# Value Engineering Study

**East Side Coastal Resiliency Project**

Preliminary  
Value Engineering Study Report  
for

East Side Coastal Resiliency Project  
New York, NY

Alternative No.: AD-10

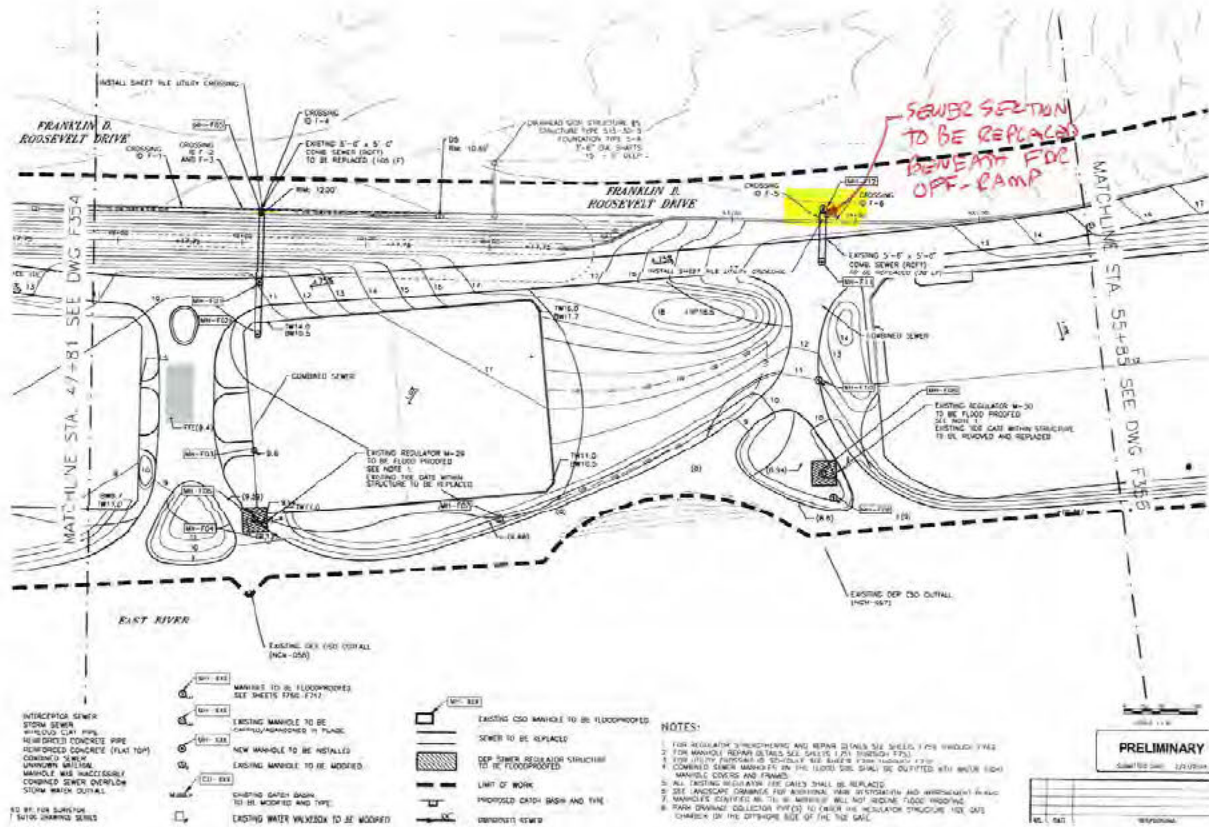
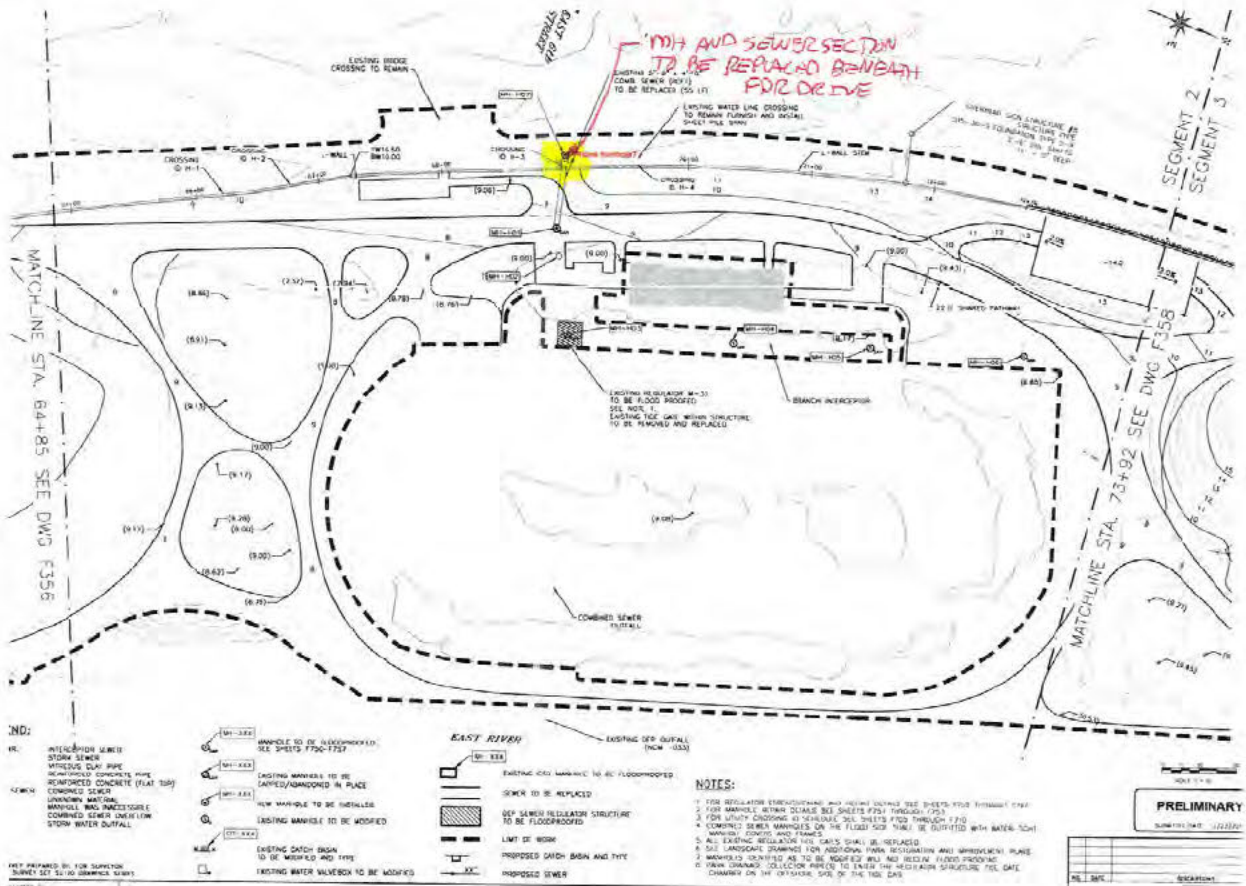
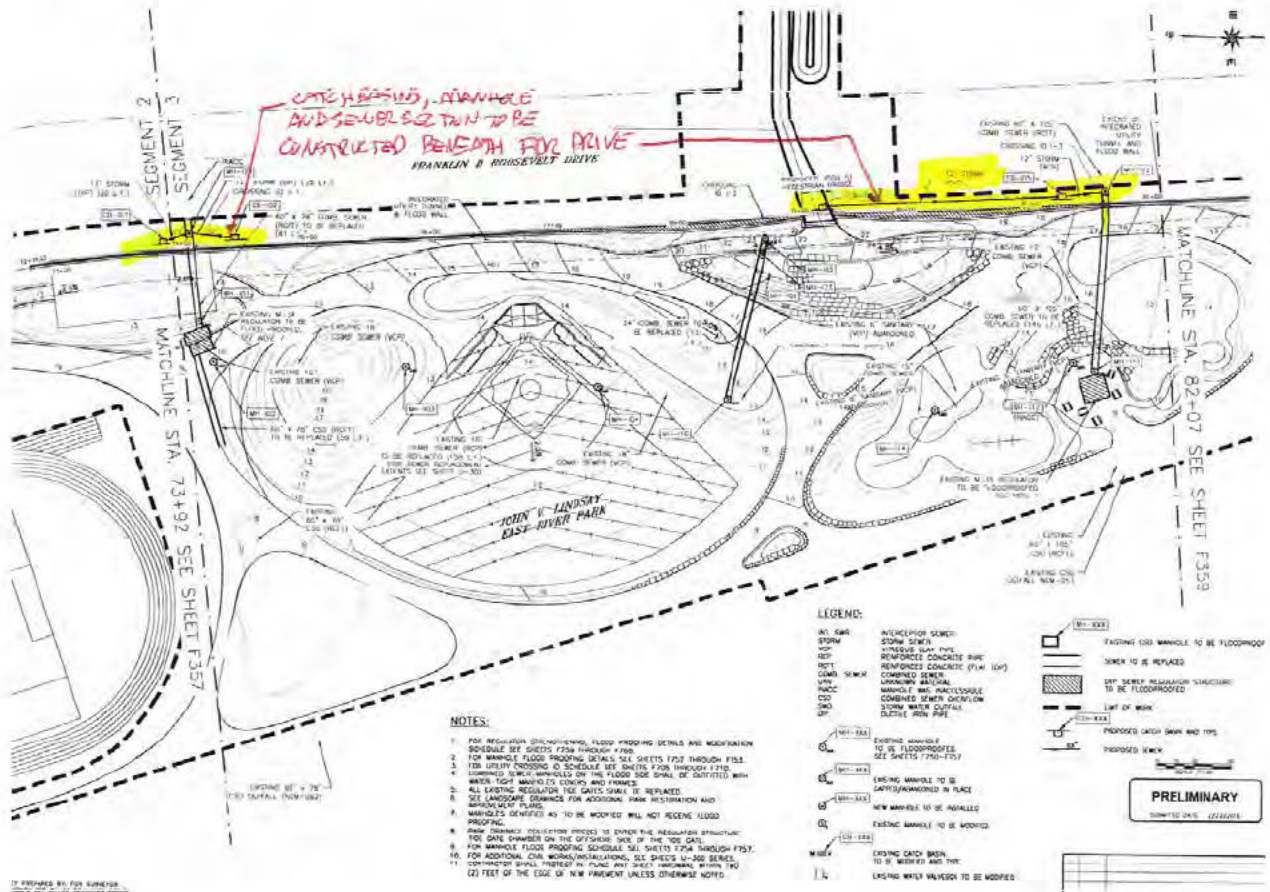
Construction, operation and maintenance requirements for the approximately 10 new CSO or storm drain manholes needed to access existing, reconstructed or replaced CSO discharge conduits to the East River would be greatly reduced by locating these manholes either on the new berm, in the park area (with flood-proofing of the structures) or west of the floodwall and FDR Drive.

Construction of these manholes would be prohibitively disruptive and, therefore, not preferred by the DOT. In addition, access to these manholes by DEP for O&M purposes would be similarly disruptive and unacceptable to both DOT and DEP.

Alternative No.: AD-23

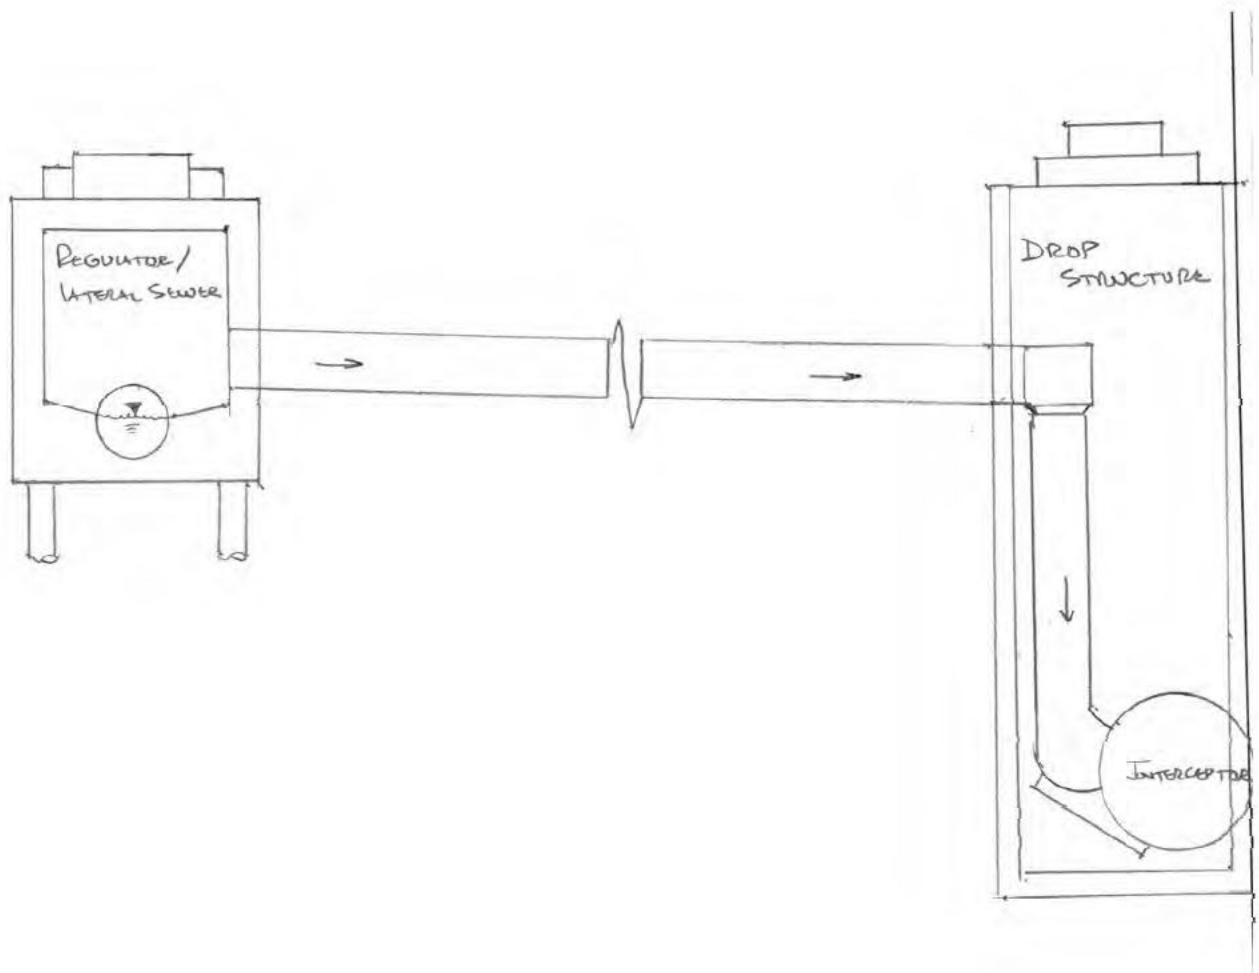
1. Clogging of the connecting pipes leading to the isolation chamber from the combined sewers. These pipes will accumulate sanitary solids, sediment and debris from storms smaller than those requiring opening of the flap gate in the isolation chamber. These solids will be very difficult to remove leading to their solidification, greatly reducing the capacity of the connecting pipes and the parallel conveyance system.

2. The isolation chamber gates are to be manually operated, requiring multiple staff both before and after major storm events to open and close the flap gates and to clean the pipes and mechanisms after each event to ensure future operability. Because of the uncertainty related to future meteorological conditions, decisions to mobilize staff to open these gates must be made early in a storm's occurrence to take advantage of the available capacity in the 108-inch interceptor and avoid surface flooding. The requirements for such a conservative decision process will lead to more frequent, unnecessary operation of the chambers. This translates to additional time for the O&M staff.

3. Without the benefit of detailed hydraulic analyses using the InfoWorks model, it appears likely that surcharging of the 108-inch interceptor to the Manhattan Pump Station will cause surcharging or backflow to the combined system with or without the proposed parallel conveyance conduits. Thus, the isolation chambers would be of little benefit hydraulically but is adding a substantial capital cost and poses very serious operation and maintenance problems that would render them inoperable and ineffective in any case.

Alternative No.: AD-41

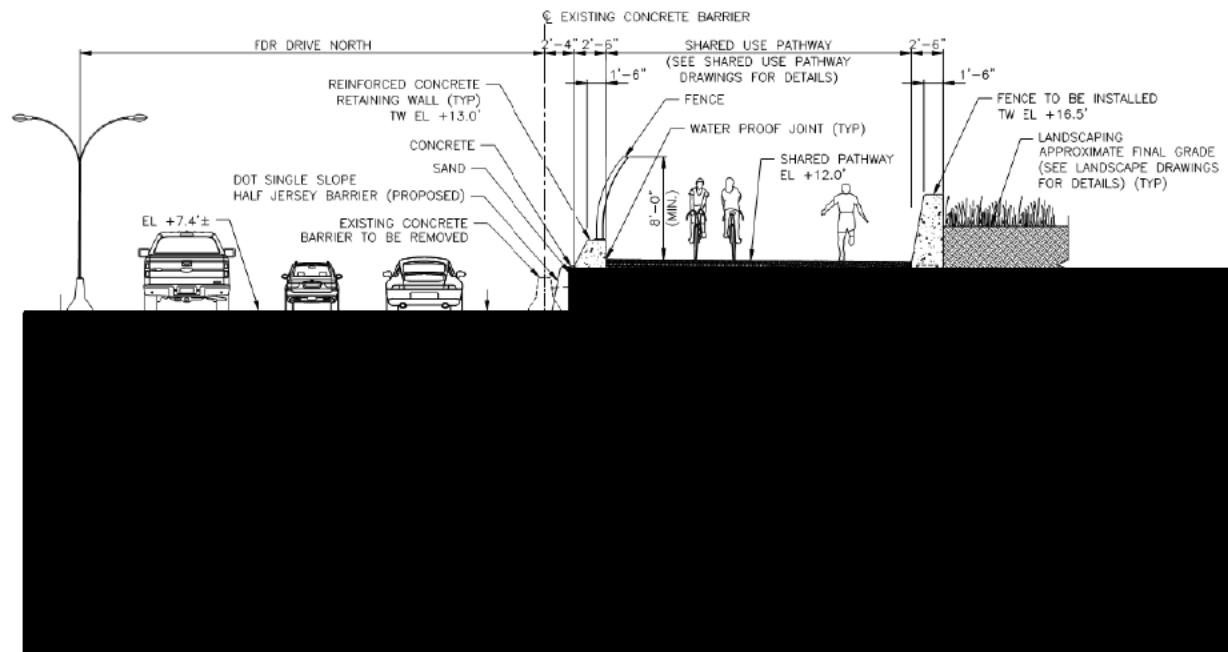
The site has been investigated with test pits and ground penetrating radar to determine the location of the transmission lines. [REDACTED]

Based on a review of the drawings there may be selected areas where it may be easier to expose the lines because of proximity of other work. The transmission lines also cross under the wall in at least two locations. If the lines are exposed by excavations necessary for the project Con Edison could inspect the lines.

Alternative No.: C-12

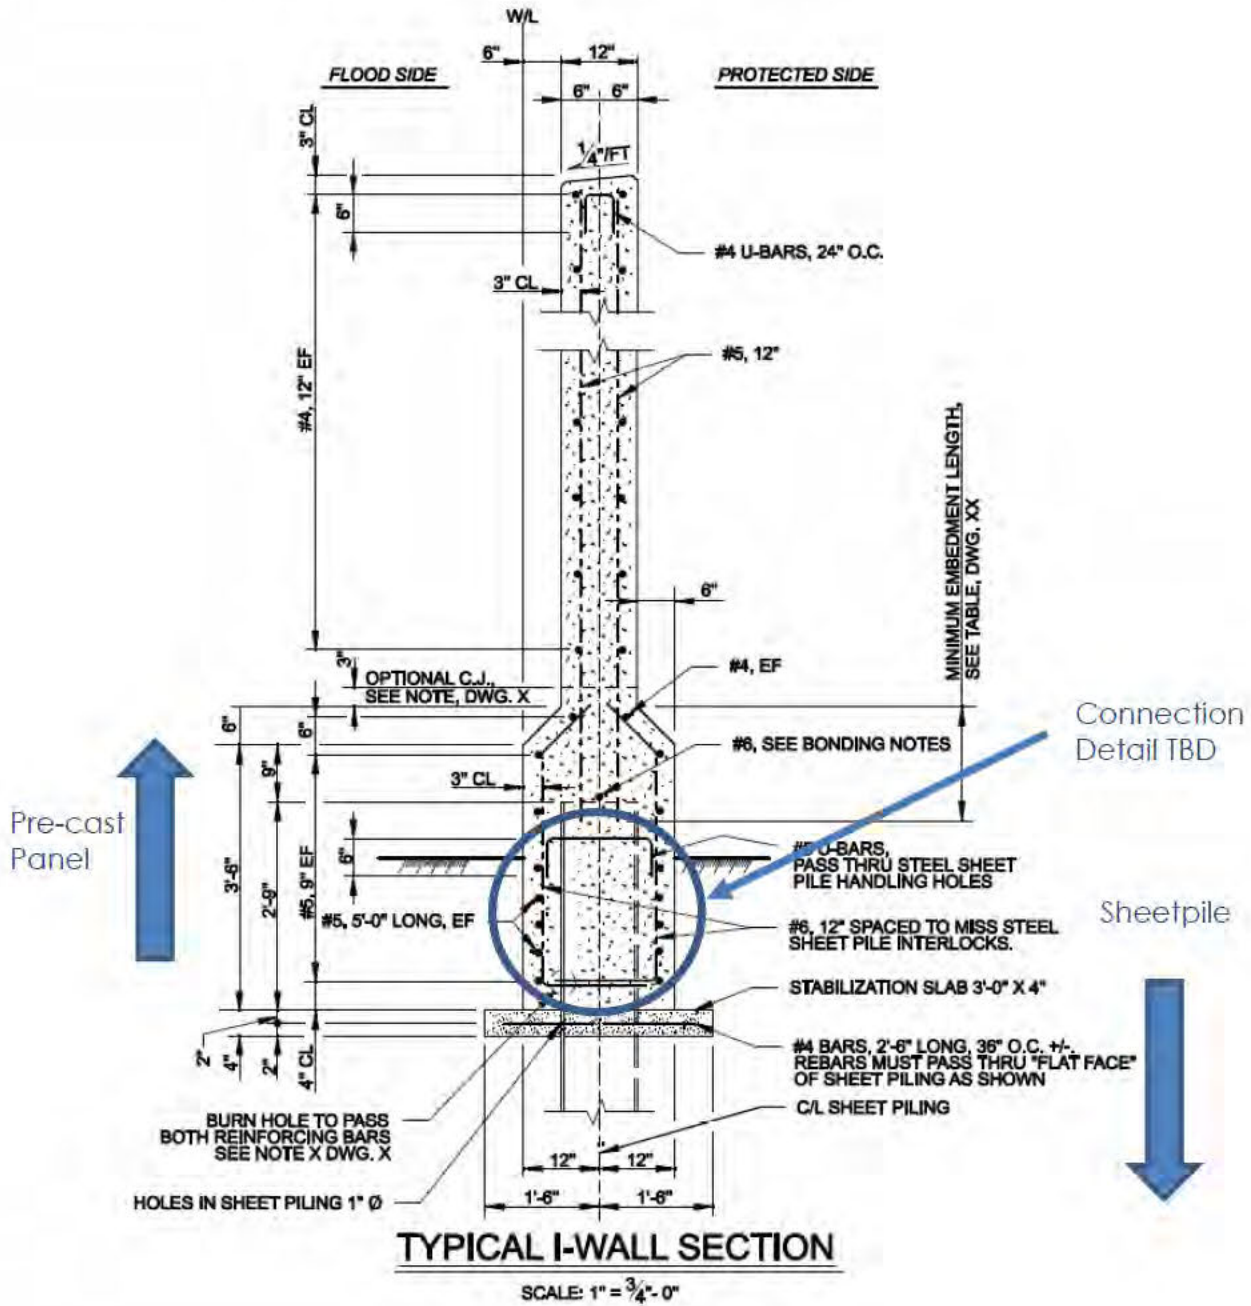
Capping the sheet pile wall by casting concrete in place to form an I-wall section is the original concept and a customary practice (see original sketch following). This alternative includes the design and construction of a pre-cast cap section that could be placed over the sheet pile cut-off and grouted in-place.

The typical detail from The U.S. Army Corps of Engineers Hurricane and Storm Risk Reduction System (HSDRRS) guidance is included in the sketch. In the typical section, holes are cut in the sheet pile to allow rebar to pass through the sheet pile at the top and bottom of the connection for the cast in place method. So "just" dropping a precast segment over the pile and grouting would not be sufficient. Some creative details for the joint would need to be developed. Aligning holes in precast and sheet pile could be an issue. And may require field drilling the sheet pile holes. The length of cap and vertical joint details will need to be designed as well.

A field test of construction and possibly load testing for a short length using this method should be piloted to ensure performance under design load.

Cap heights should be standardized to the extent possible to minimize the number of different pre-cast shapes. Transitions between wall types and major elevation changes would call for detailed design and likely cast-in place techniques.
